BCA & Access Assessment Report

Project Silverback
Oakdale East Industrial Estate, Horsley Park
SSDA 120888992

Revision 5

Reference: 260145

Figure 2: Perimeter Vehicular Access Assessment

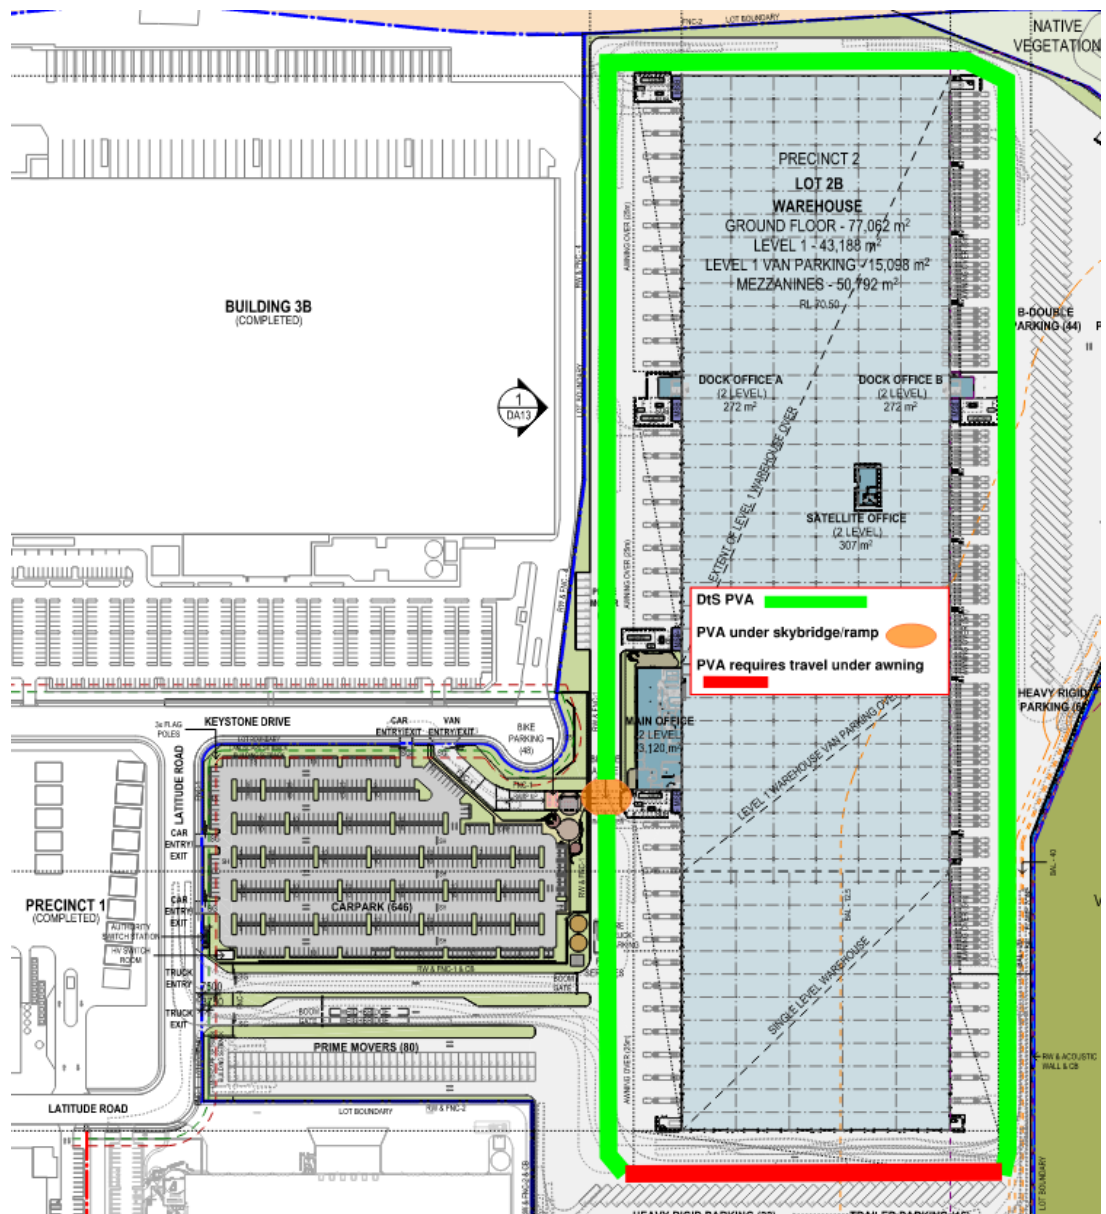
3. C3D5	A performance solution is required to address the Perimeter Vehicular Access where the path travels under the skybridge and carpark ramp on the eastern elevation of the building.

C3D4	Large Isolated Buildings: A Large Isolated Building that contains Class 5, 6, 7, 8 or 9 parts, is required to be— + Protected throughout with a sprinkler system complying with Specification 17; and + Provided with a perimeter vehicular access complying with C3D5(2). Comment: The proposed warehouse building is required to be sprinkler protected throughout and provided with perimeter vehicular access in accordance with Clause C3D5 (see notes below) pursuant to the Large Isolated Building designation under this clause.
C3D5	Requirements for Open Spaces and Vehicular Access: Open space and vehicular access required by C3D4 must comply with the requirements of sub-clauses (a) & (b) of this Part whereby they must be 6m wide within 18m of the external walls of the building and of a suitable bearing capacity and unobstructed height to permit the operation and passage of FRNSW vehicles. Comment: The proposed building does not comply with the provisions of C3D5 and thus the following non-compliance issues are required to be addressed as a Performance Solution by the Fire Engineer to demonstrate compliance with Performance Requirement C1P9: + To allow PVA to travel under the skybridge and carpark ramp on the eastern elevation of the building. + To allow PVA to travel under the awning in the southern elevation

Note 1: Any proposed gates are to achieve no less than 6m unobstructed width or the reduced width will need to be included in the above Performance Solution.

Note 3: The Trial Design for the Fire Engineered Performance Solution must take into consideration and detail the proposed security access to the site and how this may impact on FRNSW vehicular access.
